Before the FEDERAL COMMUNICATIONS COMMISSION Washington, DC 20554

In the Matter of)
Space Exploration Holdings, LLC))
Application for Modification of Authorization for the SpaceX NGSO Satellite System) File No. SAT-MOD-20200417-00037)
)

REPLY OF KUIPER SYSTEMS LLC

REPLY OF KUIPER SYSTEMS LLC

Figure 3: Satellite Beam Contours Submitted with First versus Third Modification

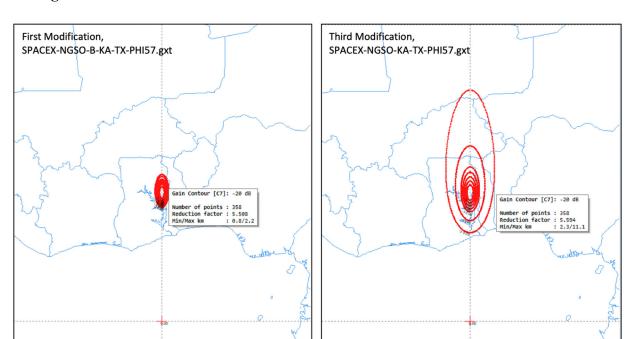
An inspection of the satellite beam contours submitted as part of the Schedule S for SpaceX's First Modification and Third Modification reveals a significant increase in contour area. This contradicts SpaceX's claim that "Operating these shells at lower altitude will significantly decrease each satellite's footprint on the Earth." Figure 3 shows a satellite beam contour submitted with the First Modification (left), and a satellite beam contour submitted with the Third Modification (right), using the satellite and beam positions in SpaceX's GXT contour files. The satellite beam contours in the GXT files are displayed using the ITU Graphical Interference Management System (GIMS) software.

The authorized satellite beam contour (Figure 3, left) covers approximately 20,000 km² of land area. The satellite beam contour in the Third Modification (Figure 3, right) covers approximately 300,000 km². The satellite beam contours above only show the beam projections from a single satellite position, which does not capture the full effect of the increased footprints. To understand how the increased interference footprint size truly affects the NGSO FSS interference environment, the envelope of footprints from all possible SpaceX satellite positions in view must be considered. This is shown below in Figure 4 with the -20 dB satellite beam contour⁷⁶ envelopes shown for the First Modification (1325 km satellite altitude: blue dotted line, 550 km satellite altitude: green solid line) and Third Modification (540 km satellite altitude: orange

Figure 4: Satellite Beam Contours, Single Satellite Position and Possible Satellite Positions

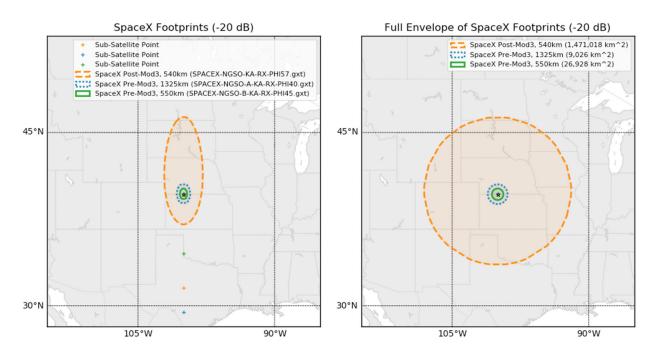
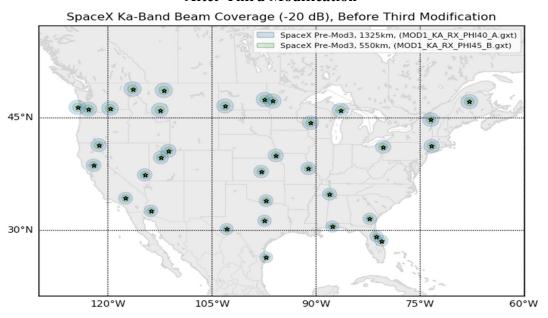
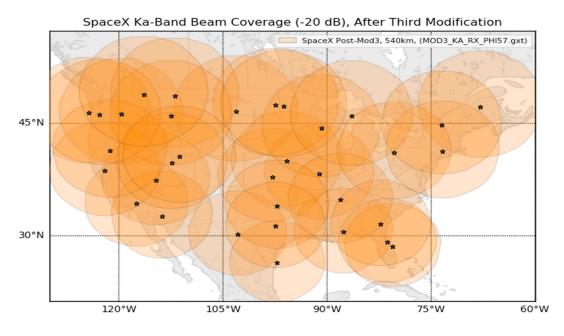
dashed line). The full envelopes of the currently authorized and Third Modification -20 dB satellite beam contours, swept over all azimuth directions from which they could be received, are shown on the right diagram in Figure 4. The Third Modification satellite beam contour (orange dashed line) covers over 50x as much land area as the currently authorized contour for satellites at 1325 km altitude (blue dotted line), and covers over 150x as much land as the currently authorized contour for satellites at 550 km altitude (green solid line).

Figure 5: Satellite Beam Contours at Select Requested Earth Station Locations, Before and After Third Modification

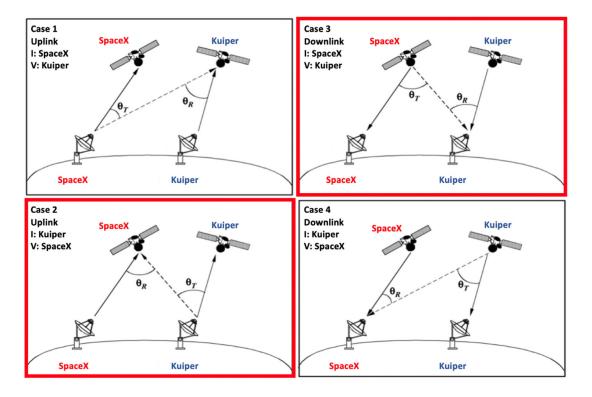
Figure 5 below shows the full envelope footprints from all SpaceX satellite positions with respect to Ka-band earth stations for which SpaceX has applied for in the United States. The impact is profound. SpaceX's proposed -20 dB satellite beam contours cover virtually the entire continental United States, essentially eliminating geographic separation between Ka-band earth stations as a sharing mechanism whether or not SpaceX has an earth station in a particular location. This broad expansion of SpaceX's beam coverage would impact both GSO and NGSO FSS Kaband earth stations and significantly alter the NGSO interference environment, dramatically

reducing the interference mitigation remedy previously possible by earth station separation and advantage SpaceX to the detriment of other Ka-band satellite operators.
